**STAFF REPORT  
HISTORIC AND CULTURAL LANDMARKS COMMISSION  
CITY OF FORT WORTH, TEXAS**

DATE: July 10, 2017

<b>REQUEST</b>	Certificate of Appropriateness
<b>APPLICANT/AGENT</b>	Dustin Collett/Priscilla Gish
<b>LOCATION</b>	1622 College Avenue
<b>ZONING/ USE (S)</b>	C/HC
<b>NEIGHBORHOOD ASSOCIATION</b>	Fairmount Southside

The applicant requests a Certificate of Appropriateness for a previously-constructed second-story addition.

Figure 3. Roof Plan showing the as-built addition bubbled

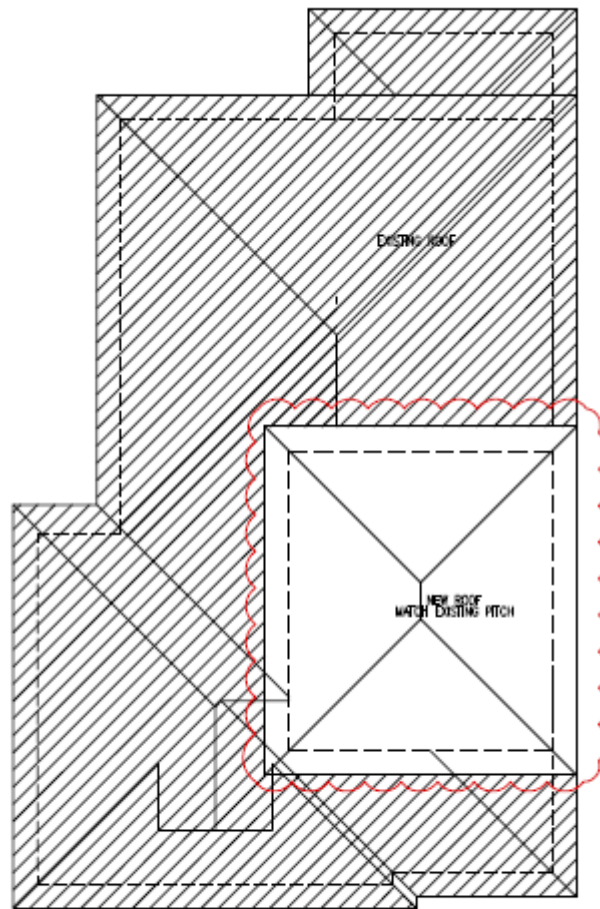
On **September 19, 2013**, Staff received a complaint that the addition was not being constructed as approved by the HCLC. The addition was constructed approximately 9-10' from the front wall of the structure and was increased in width to accommodate structural and building code issues.

The as-built construction required a greater intervention to the roof form that characterized the single-story bungalow than that which had been approved in August 2013. The additional width contributed to the appearance of an increased mass with a greater adverse effect on the setting of the historic home. Since other solutions would have been available that would not have resulted in such adverse effects, the as-built condition does not meet **Standard 1** of the *Secretary of the Interior's Standards for Rehabilitation*, which requires minimal change.

If the structure needed to be widened, this could have been achieved without also pulling the addition forward, essentially lengthening the addition, so that it required the alteration of the front (east-sloping) roof plane up to the ridge. For example, the decision to place the bathroom and the front bedroom in front of the stair location would appear to be unrelated to the need to widen the structure. Thus, the structure was not only widened but it was lengthened as well, the latter of which there does not appear to be justification. In addition, the indication that the floor needed to be widened by three feet does not explain why the north (side) wall of the addition wasn't set-in by three feet because this would have helped to reduce the impact of the mass and as a result of narrowing floor plan, it would have also lowered the roof height. There are many solutions to these type of design challenges, and it is considered that alternative solutions could have been designed so as to meet the Fairmount Standards and Guidelines and the *Secretary of the Interior's Standards for Rehabilitation*.

The key issue with the non-compliant addition is its forward positioning. The positioning of the structure accentuates its mass and adversely affects important character-defining elements of the historic structure, including its roof form and setting. A secondary issue is the widening of

1. That the as-built addition be set back to facilitate the reinstatement of not less than 1'-0" of the primary historic roof ridge, the complete reinstatement of the front (north) facing roof slope, and the corresponding portion of the east roof slope, to their respective August 2013 forms;
2. That a Temporary Protection Plan identifying the potential risks associated with the execution of the mitigation measures and detailing how those risks will be mitigated to ensure that the historic structure is protected from any damage, be submitted to the Planning and Development Department along with the final plans depicting the mitigation measures;

Figure 4. Front (East) elevation showing the as-built condition

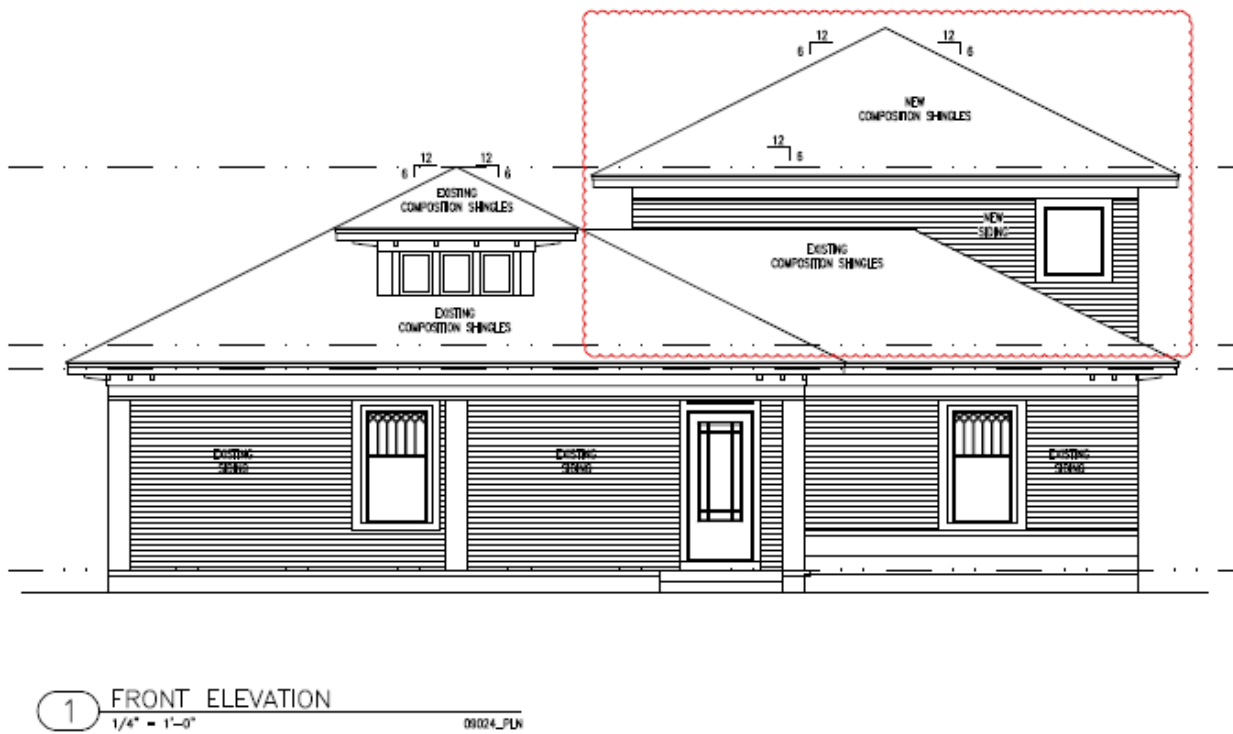
The previously-constructed second-story addition is generally consistent with the height and overall scale of adjacent structures in the immediate vicinity in that it does not exceed the height of adjacent structures by more than one story. However, a considerable difference between the approved scheme and the as-built condition rests in the extent to which the addition is setback from the front of the house, the increase in roof height arising from the widening of the addition during construction, and the resulting degree to which the addition satisfies the key preservation principle of inconspicuousness. The physical impact on the character-defining roof of the original house and its setting are considerable. The extent of setback not only demonstrates that the approved scheme approached inconspicuousness, but that such a setback also resulted in safeguarding the original roof form and the primary roof ridge of the house. The effect that the as-built addition has on a character-defining roof of the house amounts to a truncated pyramidal roof form, which adversely impacts the original profile of the roof – one that is also highly visible from the public right-of-way. In this regard, the as-built addition does not satisfy Standard 14, Section 5 of the Fairmount Historic District Standards and Guidelines, where it states that *additional stories shall be set back from the roof edge to ensure that the historic building's proportions and profile are not radically changed.*

The historic character of the single-story bungalow was not retained and preserved because the as-built addition resulted in the alteration of a character-defining roof and the placement of the

mass of the new addition in a way that was uncharacteristic. In this regard, the as-built condition would not meet **Standard 2** of the *Secretary of the Interior's Standards for Rehabilitation*.

Fig. 7 – Proposed Site Plan Modifications

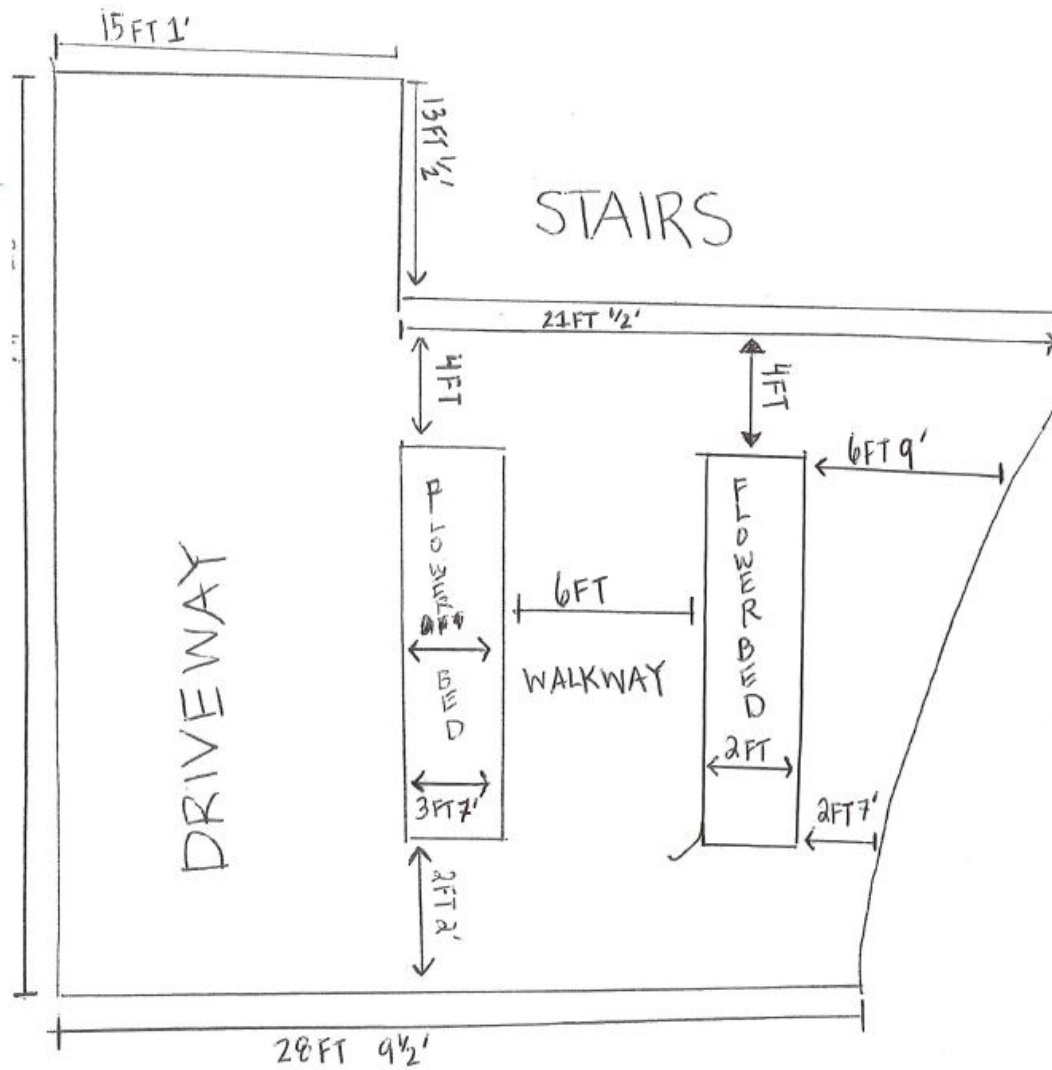
The property at 1210 W. Richmond Ave. is a one-story residential structure built in 1985 according to TAD records. It is not a contributing structure in the Fairmount/Southside Historic District. The applicant is requesting to retain a recently installed concrete front yard, add a 6 ft. walkway, and add a 2'-0" x 4'-0" flowerbed to the subject area.

**That the request to retain a recently installed concrete front yard, add a 6 ft. walkway, and add a 2'-0" x 4'-0" flowerbed to the subject area be denied.**

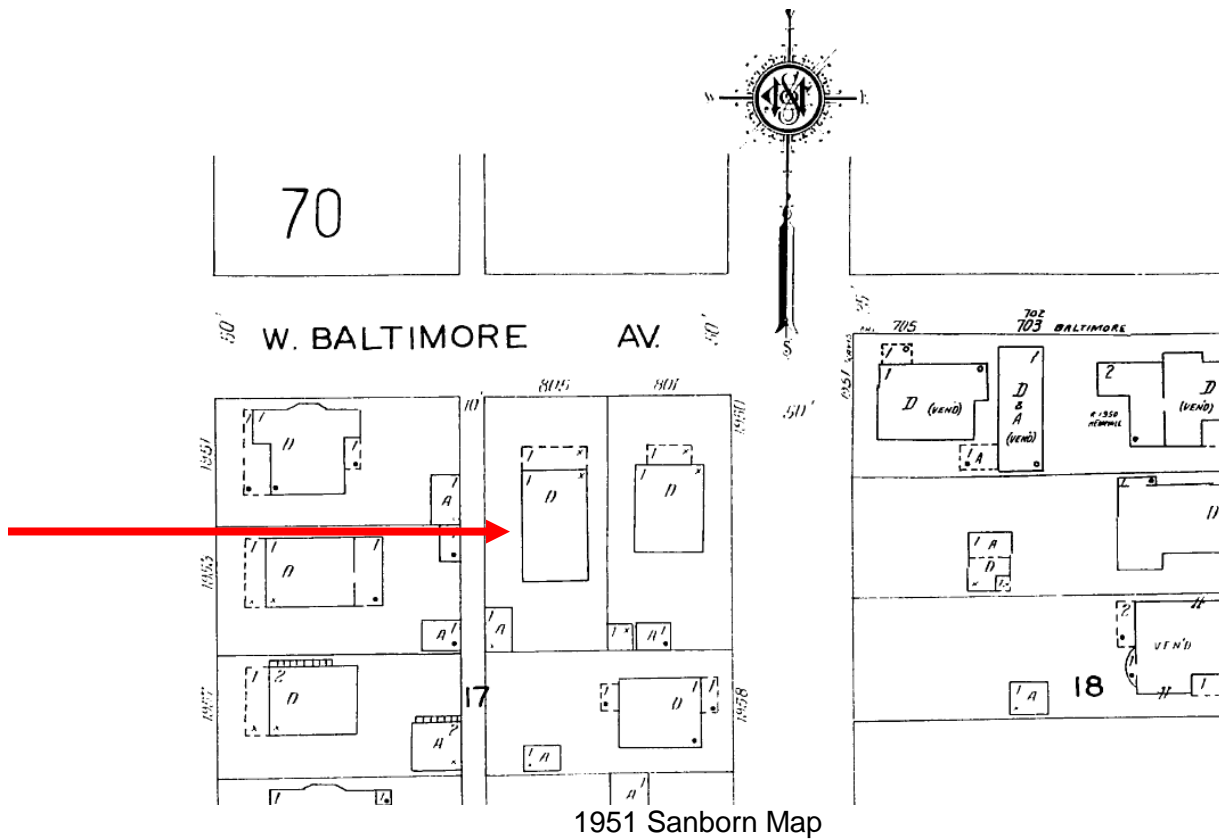
The height and overall scale of the new addition is not consistent with the existing structure. Craftsman Bungalow style buildings generally do not have a full hipped roof on the front façade. The second story exterior walls of the proposed addition use the same wall plane as the original structure and is not set back from the roof edge. Overall, the size, scale, massing and proportions of the new addition are inconsistent with the Fairmount Design Standards and Guidelines and the *Secretary of the Interior's Standards for the Treatment of Historic Properties*, Standards for Rehabilitation & Guidelines for Rehabilitating Historic Buildings, New Additions to Historic Buildings. These federal Guidelines recommend constructing a new addition so that there is the least possible loss of historic materials and so that character-defining features are not obscured, damaged, or destroyed. The federal Guidelines also recommend locating the attached exterior addition at the rear or on an inconspicuous side of a historic building; and limiting its size and scale in relationship to the historic building. The proposed 2<sup>nd</sup>-floor addition is inconsistent with both of these recommendations. The positioning of the addition will not have an adverse impact on the setting of the original residence because the applicant has amended the drawings to set the addition back from the apex of the roof.

**That the Application for a Certificate of Appropriateness to construct a second-story addition and rehabilitate the exterior of the primary structure be approved subject to the following conditions:**

- 1. That the applicant set back the east and west walls of the proposed addition at least 1' on each side from the existing wall plane of the original structure; and**
- 2. That a preservation-based window condition assessment be provided and that the applicant depict fenestration patterns on all facades consistent with the Fairmount Design Standards and Guidelines ; and**
- 3. That the window condition assessment and updated annotated drawings that are informed by the assessment be submitted to staff prior to the issuance of a Certificate of Appropriateness**

Figure 9. Existing and proposed south elevation

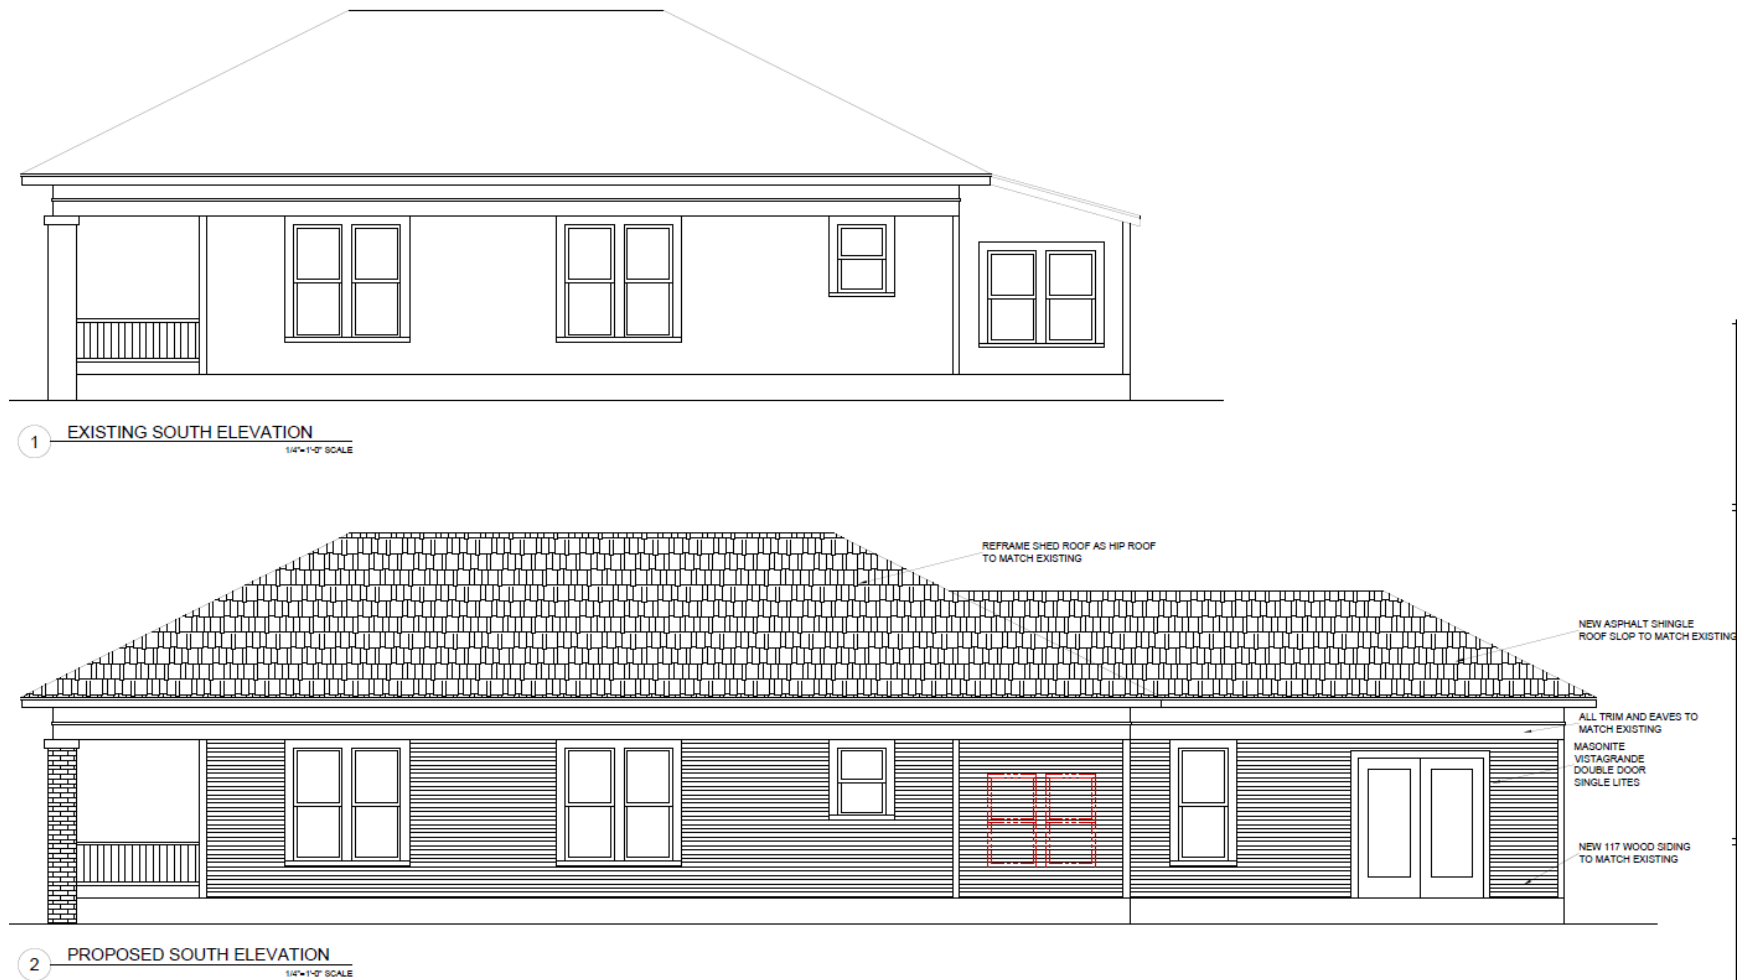
A predominant character-defining feature of the historic bungalow is its simple hipped roof form with a shed-roof lean-to. The "footprint" of the original roof is therefore an important character-defining feature. This includes the four hips, whose returns, provide a specific three-dimensional character to the roof form. The roof extension would be primarily visible from W. Morphy Street.

The proposed addition involves the incorporation of the lean-to, giving it the same hierarchy as the original main roof. The original roof form would therefore be elongated in order to accommodate the existing lean-to. Extending the same roof plane would not differentiate the addition from the original roof form. Incorporating the lean-to makes it appear part of the historic bungalow, which is inconsistent with Sections 5 and 7 of the Fairmount Historic District Standards and Guidelines.

- 1. That the roof extension over the lean-to be designed so as to maintain the original roof shape of the primary hipped roof and that the drawings be amended to satisfy Standard 1, Section 7 – Standards and Guidelines for Roofing, Fairmount Historic District Standards and Guidelines, and submitted to the Planning and Development Department prior to the issuance of a Certificate of Appropriateness.**
